Subject: Duke Energy
Oconee Nuclear Station, Unit 2
Docket Nos. 50-270
Third Ten Year Inservice Inspection Interval
Requests for Relief No. 04-ON-002 and 003
Request for Additional Information

**REQUEST FOR ADDITIONAL INFORMATION
ON THIRD 10-YEAR INSERVICE INSPECTION INTERVAL
REQUESTS FOR RELIEF 04-ON-002 AND 04-ON-003**

TECHNICAL LETTER REPORT
REQUEST FOR ADDITIONAL INFORMATION
ON THIRD 10-YEAR INSERVICE INSPECTION INTERVAL
REQUESTS FOR RELIEF 04-ON-002 AND 04-ON-003
FOR
DUKE POWER COMPANY
OCONEE NUCLEAR STATION, UNIT 2
DOCKET NUMBER 50-270

Attachment C
Page 3 of 59

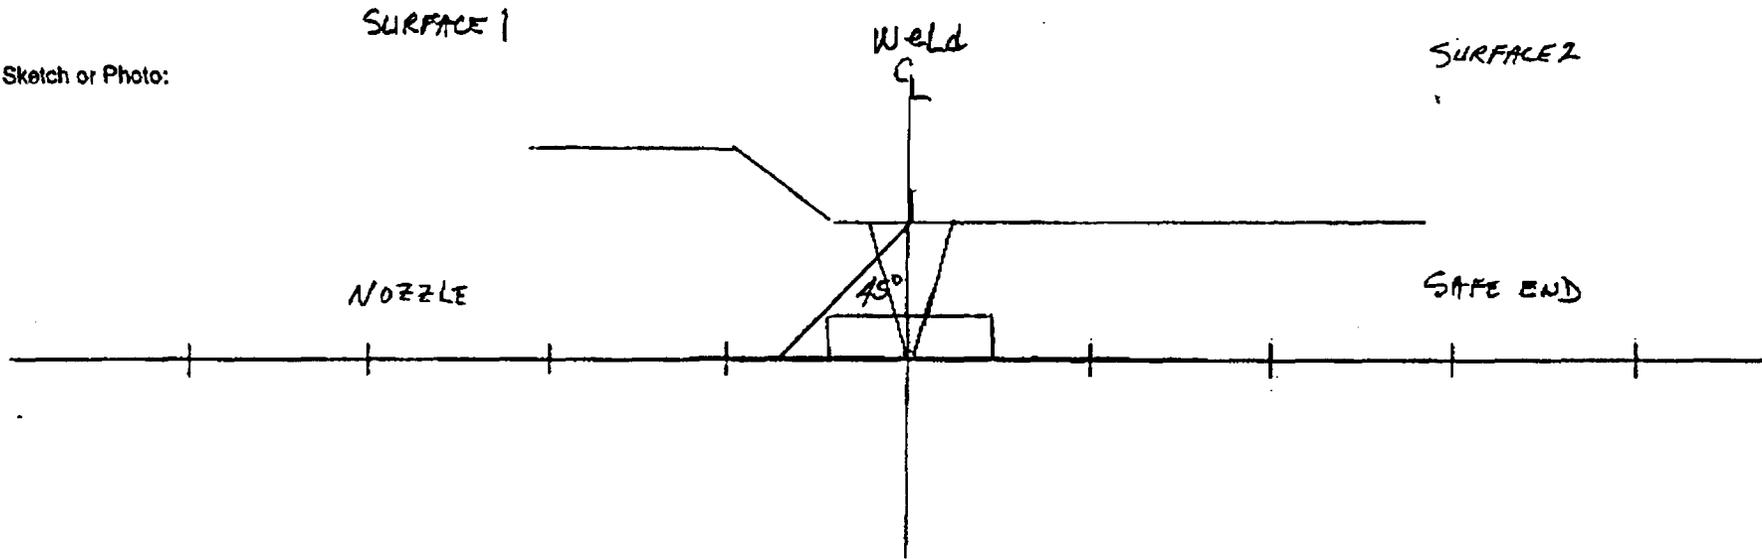
Attachment C, page 3 of 59, shows a UT profile/plot sheet for Weld 2-PZR-WP45. Please clarify what is depicted on this sheet; specifically, describe the relevance of the 60° notation in the sketch.

Answer: One hundred percent coverage was achieved scanning from the safe end side of the weld using 45 degree shear wave and longitudinal wave search units. An axial scan from the nozzle side of the weld could not be performed because of the nozzle taper. Circumferential scans were performed over 100% of the examination volume in two opposite directions. The 60 degree notation is an error. It should read 45 degrees. A revised drawing (page 3 of 59) is enclosed. A review of the nozzle detail drawings shows no buttering at this weld location.

(Revised to show 45 degree angle)

Photograph of BWST

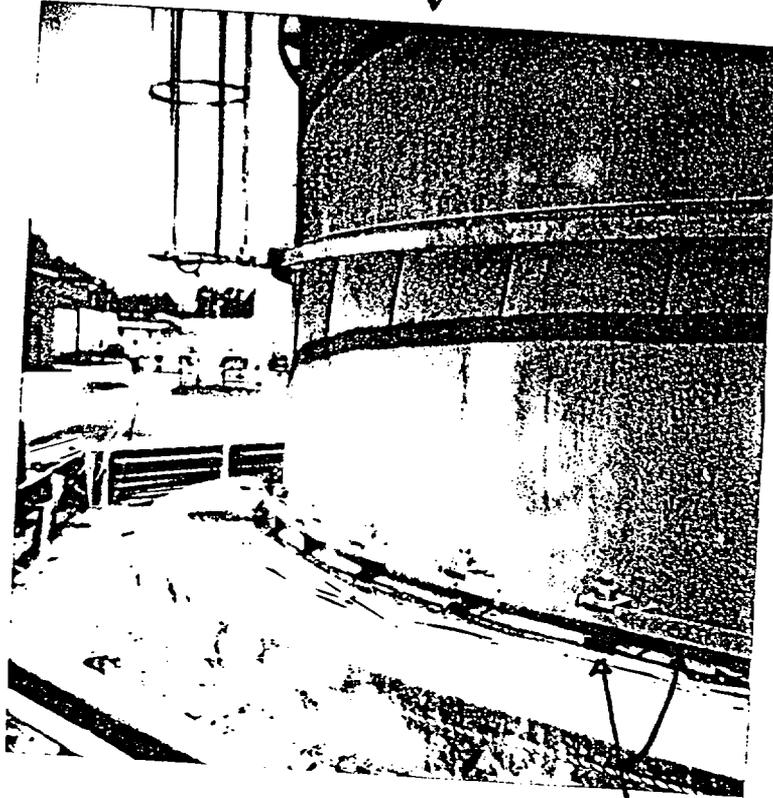
Confirm that BWST stands for *Borated Water Storage Tank*, and confirm that this tank and associated piping is low carbon steel. In addition, further describe the surface area limitation caused by the steel support member (a sketch or photograph would be useful - no sketch was included in the Liquid Penetrant Report, Attachment C, page 58 of 59). The licensee stated that magnetic particle examination was performed on this socket welded joint, however a liquid penetrant report is included. Clarify which type of surface examination was actually performed. Finally, report any other examination results for similar components (large diameter C-F-2, Item C5.70 socket welds) that were performed during the interval.

Answer: BWST stands for Borated Water Storage Tank and the material associated with the tank is A283 GR.C carbon steel, the piping material is A-106 GR B carbon steel and the flange material is SA-181 carbon steel. There are several factors that contribute to the surface area limitation. The first factor is that the BWST is sitting on a concrete base of which the bottom of the piping associated with the limited weld is located at approximately 5 inches from the concrete base surface. The second factor is that the backside of the flange surface is located only 2.75 inches from the BWST wall surface and the distance from the outside diameter of the flange to the concrete base surface is only 2.187 inches. The third factor is that there are 39 anchor bolt brackets evenly spaced around the bottom of the BWST that have a siding plate attached to the anchor brackets. One of the anchor brackets is the support steel member that has minimum clearance from the pipe which was noted in Paragraph I of Relief Request 04-ON-002. It is this very confined space that caused the liquid penetrant examination to be limited. A liquid penetrant examination was the method of surface examination performed on this weld. Paragraph I in Relief Request 04-ON-002 was corrected (enclosed) to show that a

Liquid Penetrant exam was performed. There were no other C05.070 items examined during this inspection interval.
